9.5 ROBERTSON PARK DEVELOPMENT PLAN

To seek Council's endorsement of the Robertson Park Development Plan (**Attachment 1**) and note the submissions received during the community consultation period (**Attachment 2**) on the draft Robertson Park Development Plan (**Attachment 3**).

ROBERTSON PARK DEVELOPMENT PLAN

Removal of tennis shade huts:

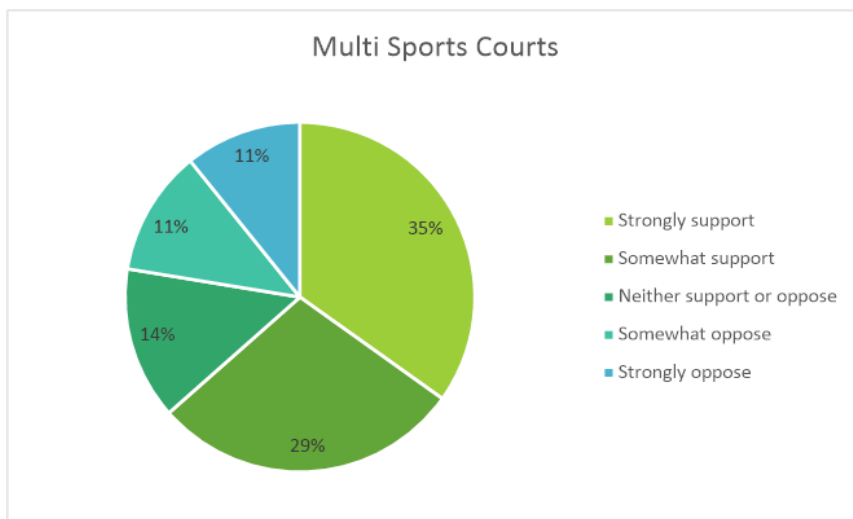
36.2% of submitters were in support of removing the shade huts, while 19.7% were opposed to the removal. There were comments surrounding the huts being part of the parks history and the need to ensure shade is at the facility.

It is understood the shade huts are part of the history at Robertson Park and shade is a preferred amenity for tennis. Shade is not a required amenity when planning a tennis centre, however, it is a preferred amenity. Administration have included shade in the revised plan and where feasible the new shade structures will interpret and reflect the original design.

Dog exercise area

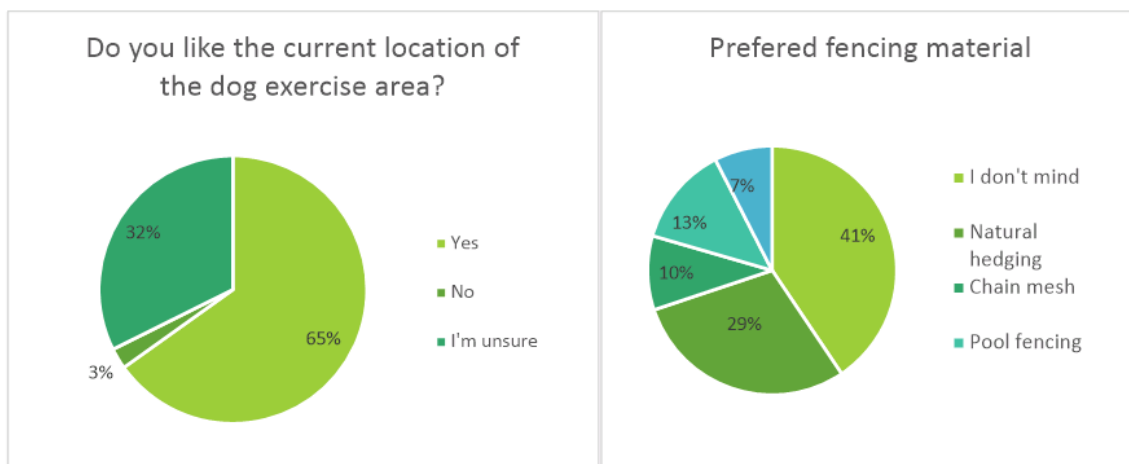
The dog exercise area is currently a popular off leash dog exercise space. The online survey shows 67% support for the enclosed dog exercise area.

Administration spent time on site speaking with dog walkers. Throughout the discussions it was clear an enclosed dog exercise area was not fully supported. However, improved fence lines were.

Given the community comments, the dog exercise area was further investigated by Administration. In the revised plan the City proposes to extend the fence line and put in a low retaining wall that serves as a small fence and seat. This will help to improve the safety of both park users and dogs.

The submitters did not want to see intrusive fence lines throughout the dog area, pool fencing with natural hedging was preferred. In the survey results natural hedging was also a popular fencing material. After seeking advice from our parks team, natural hedging has been attempted at Robertson Park in previous years and was never able to grow successfully. Given this, the fence line extension is proposed as low pool fencing with natural hedging.

Public Toilet

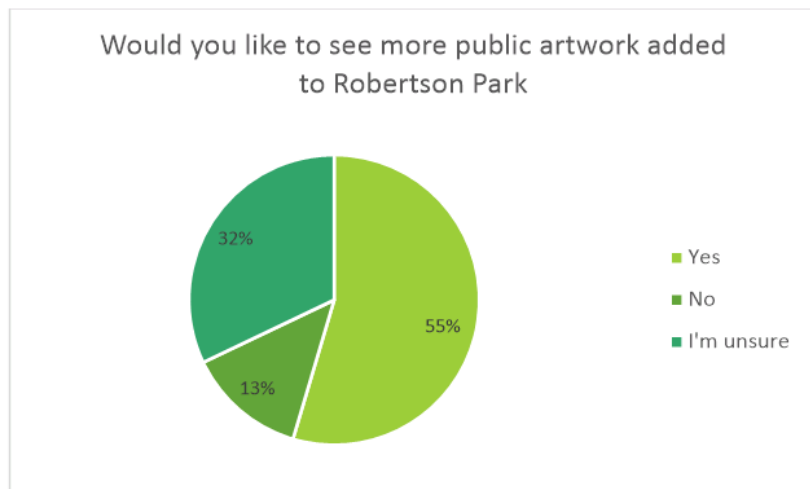
70% were supportive of a public toilet. There is concern over the location and anti-social behaviour. Given this, the toilet location has been revised. The new location is in a more visible area reducing opportunities for anti-social behaviour.

Dog Exercise Enclosure

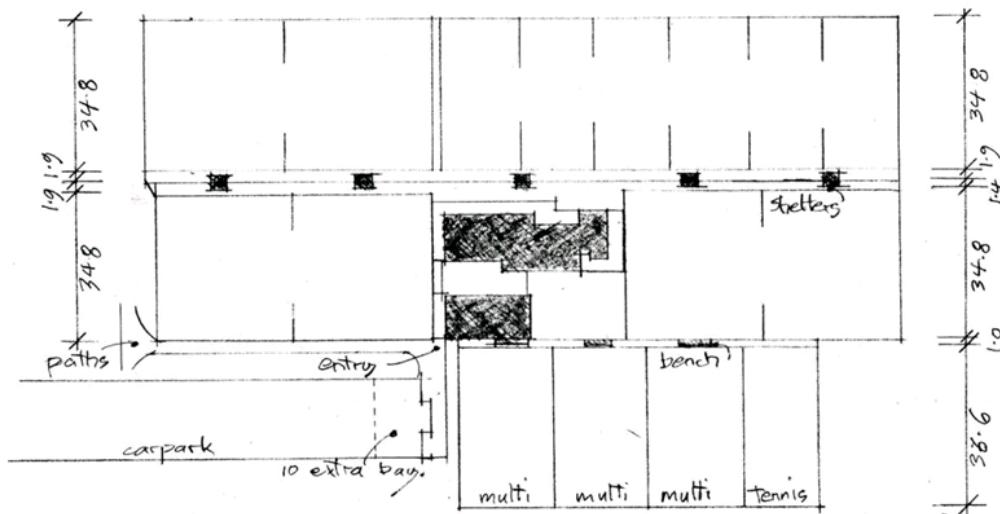
The current dog-exercise area occupies most of the space left behind after the abandonment of the Women's playing field, that was used exclusively for women's hockey and lacrosse from approximately 1925 to 1955. Its maintenance as an open space is therefore of some historical significance. Its current use as a dog-exercise area goes back well before 1980 and has become in itself part of the park's history.

The FORP are aware of the extensive discussion that has taken place amongst park users about how this open space should evolve as part of the proposed redevelopment. Council's direct consultation will inevitably throw up lots of thoughts on this matter, but it appears to the FORP, from its members' direct contact with other park users, that there is a consensus that the proposed internal fenced area should not be constructed, and instead, that the enclosure of the existing larger area should be completed. The FORP therefore support this outcome, and encourage the fence line to follow the edge of the existing path until it meets the western edge of the former Women's Playing Field which it should follow to meet the existing fence on Stuart St.
